DRIVEABILITY—MALFUNCTION INDICATOR LAMP (MIL) ILLUMINATED—AND/OR DIAGNOSTIC TROUBLE CODES (DTC'S) P0442, P0455, P0456, P0457	Article No. 02-20-7

FORD: 2001 ESCAPE
2001-2002 WINDSTAR

Article **01-17-2** is being republished in its entirety to update the model year coverage.

Figure 1 - Article 02-20-7

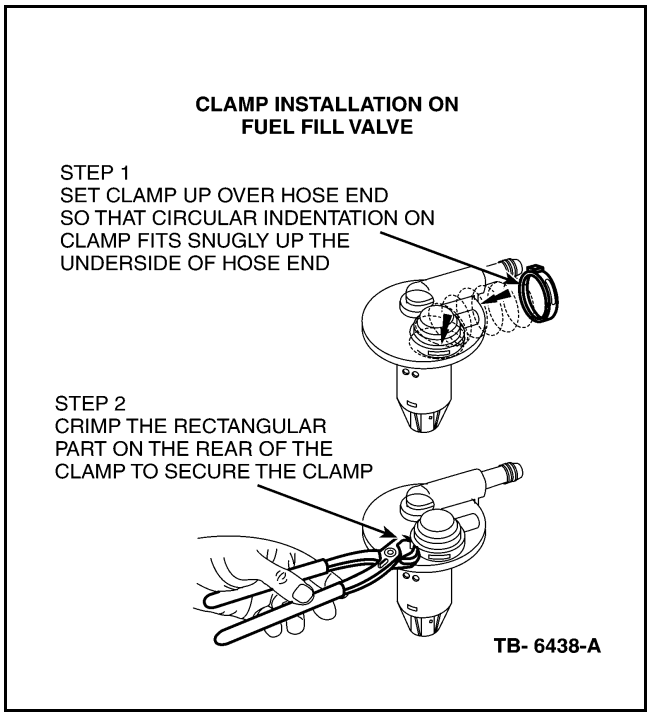
Some vehicles may exhibit an Malfunction Indicator Lamp (MIL) illuminated, and/or Diagnostic Trouble Codes (DTC's) P0442, P0455, P0456, P0457. This may be due to a small fuel vapor leak coming from the Fill Limit Vent Valve (FLVV) Over Pressure Relief (OPR) port area, of the Evaporative Emissions System (EVAP).

For the 2001-2002 Windstar, install a clamp (part number 1F2Z-9A064-AA) on the Over Pressure Relief portion of the Fuel Tank Fill Limit Vent Valve.

2. Remove the fuel tank as outlined in the Workshop Manual Section 310-01.
3. Install a Clamp 1F2Z-9A064-AA on the (OPR) portion of the (FLVV) using a Rotunda Keystone Clamp Installer (part number T63P-9171-A), see Figure 1.
4. Re-install the fuel tank per Workshop Manual.
5. Leak test the (EVAP) system to confirm all leaks have been repaired.
6. Using the NGS or WDS tool clear the (DTC's) as related to the repair.
